### **EWC-1 ELECTRIC WATER COOLER**

## Shop Drawing Submittal Review

Project Name: Webster University-**ISB**

SPEC SECTION: 22 4716  
Pressure Water Cooling

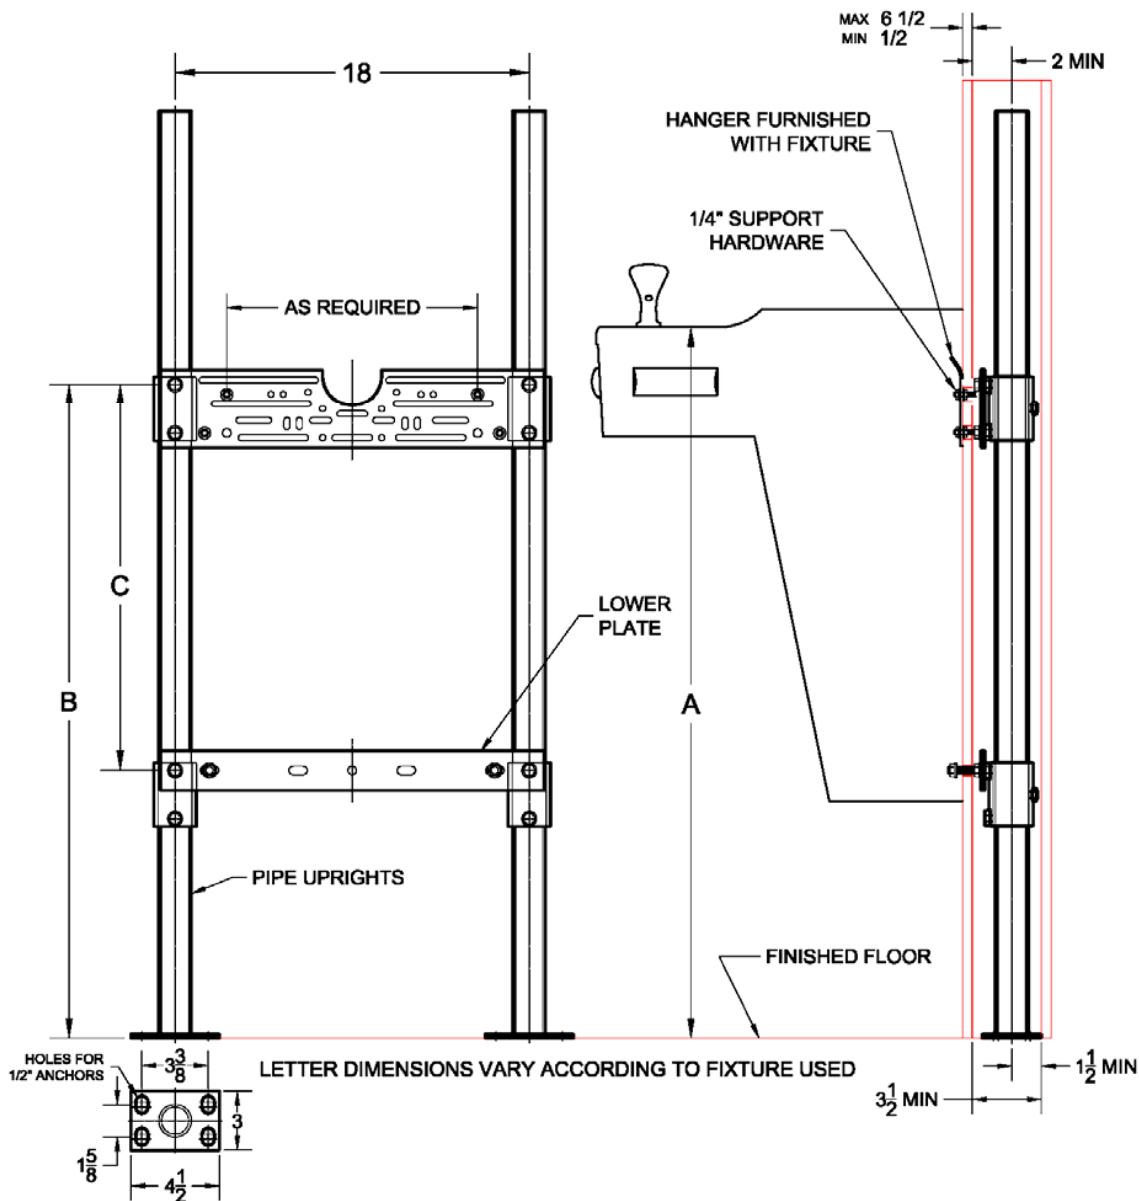
1. Owner requested change to teh following:  
Elkay  
Model - LRPBGRNM28RAK  
to include optional Vandal-Resistant Bubbler  
(See cut sheet attached)
2. Fixture carrier to be compatible with the water cooler selection.

| NO EXCEPTION TAKEN |     |     |     |     |                                                    |                                                                                                                                                         |
|--------------------|-----|-----|-----|-----|----------------------------------------------------|---------------------------------------------------------------------------------------------------------------------------------------------------------|
|                    | X   |     |     |     | Pressure Water Cooler<br>Elkay<br>Model EMABFTLR8C | 1. Owner requested change to the following:<br>Elkay<br>Model LRPBGRNM28RAK<br>To include optional Vandal-Resistant Bubbler<br>(See cut sheet attached) |
